## **Lafayette, Louisiana**

Evangeline Thruway US 90/US 167 Corridor

S.P. No. 700-24-0073  
F.A.P. No. DE-0009(802)

### **BRIEFING PACKAGE PROPOSED DESIGN MODIFICATIONS TO FEIS SELECTED ALTERNATIVE**

EXHIBIT 6  
TYPICAL MAINLINE SECTIONS

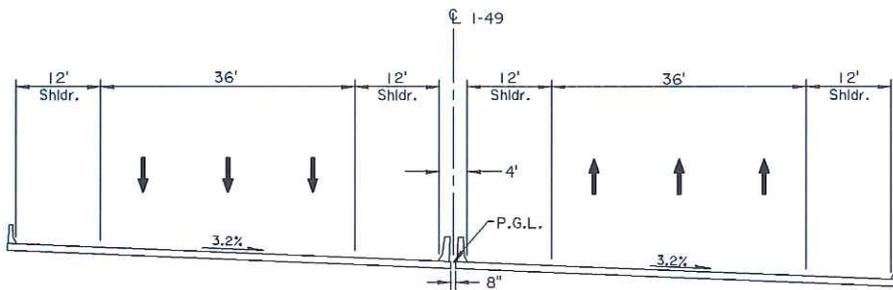
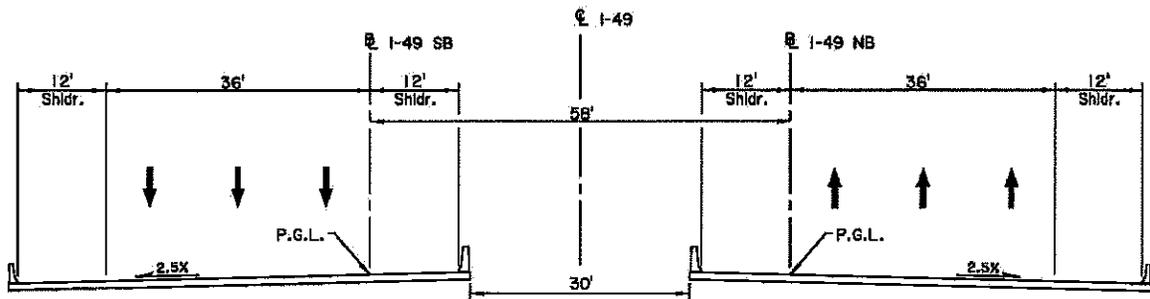
This design modification has been requested by local community groups and Lafayette Consolidated Government (LCG) based on input during the Context Sensitive Solutions (CSS) working group meetings in the summer of 2007. The main purpose of a wider separation was to improve under bridge use opportunities in the Core Area by allowing more sunlight between the two mainline structures. The Selected Alternative presented in the FEIS and ROD showed minimal separation to minimize impacts of the project, and thus, the original preliminary geometric layouts included less than a foot of separation between structures. The typical sections prepared for the core area geometric layouts during the preliminary design are shown in Exhibit 6.

As a result of this local input, LaDOTD and FHWA began the process to study impacts of widening the mainline structure separation within the core area primarily between Pinhook and Railroad Spur south of Willow. Based on commitments in the EIS & ROD, the following primary guidelines were used while developing this alternative in order to minimize impacts:

### EXHIBIT 7

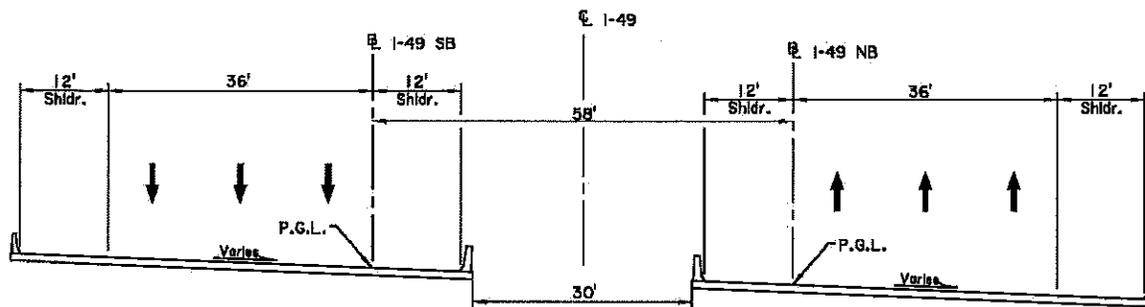
- A compound curve north of Vermilion River which is used to achieve transition between 4' and 30' transition;
- One simple curve (aprox. 5300' radius) along I-49 mainline between Pinhook Rd. and Mudd Ave. with 30' separation entire length of curve and tangents entering and exiting the curve. It is noted that this curve was created by offsetting the original northbound edge of pavement to achieve the 30' separation in order to minimize impacts to the east of the mainline, in particular to the Sterling Grove Historic District;

- As a result of the mainline being shifted further to the west, the railroad near Johnston St. Interchange will need to be relocated to allow for Johnston St. ramps and overall more right of way will be required to the west of the I-49 Connector mainline within this core area;

- Three centered compound curve on I-49 near Willow to achieve a transition from 30' to 17' median.

A typical section depicting the 30' separation of structures is shown in Exhibit 7.
